NFPA 70®-2020 Edition

TIA Log No.: 1537

Reference: 210.8(A)(7), Exception (new)

Submitter: Matt Williams, Association of Home Appliance Manufacturers

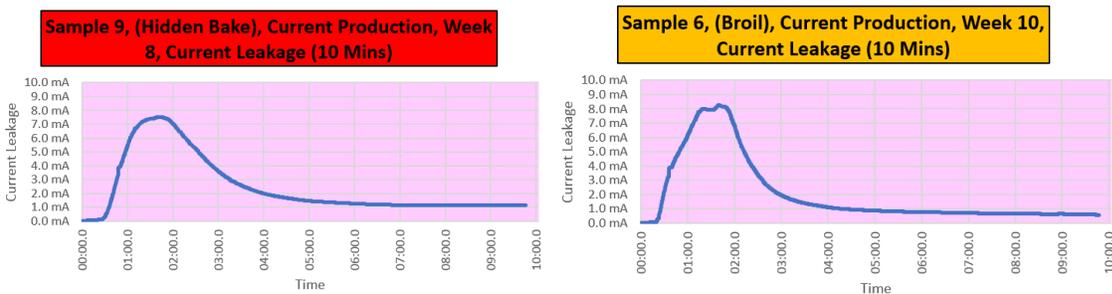
Data shows the range incompatibility issue exists with multiple range manufacturers and multiple breaker manufacturers. The issue is shown in the graphs below. At the initial start-up of the range there is moisture in the elements, the moisture causes leakage current. The moisture is driven off as the element heats up the first time and will not be re-introduced when in the home. The initial spike is above the leakage current limit for a break and will cause the breaker to trip. See the graphs below from the initial runs on a bake and a broil element.

The leakage current is back within acceptable limits within 4 to 5 minutes and will stay there when in operation after this initial startup. The range safety standard does not currently measure leakage current above 125 Volts(see clause 55).

Exception to (7): For receptacles rated 30 through 50 amperes that are supplied by single-phase branch circuits rated 150 volts to ground or less, this requirement shall become effective January 1, 2023.
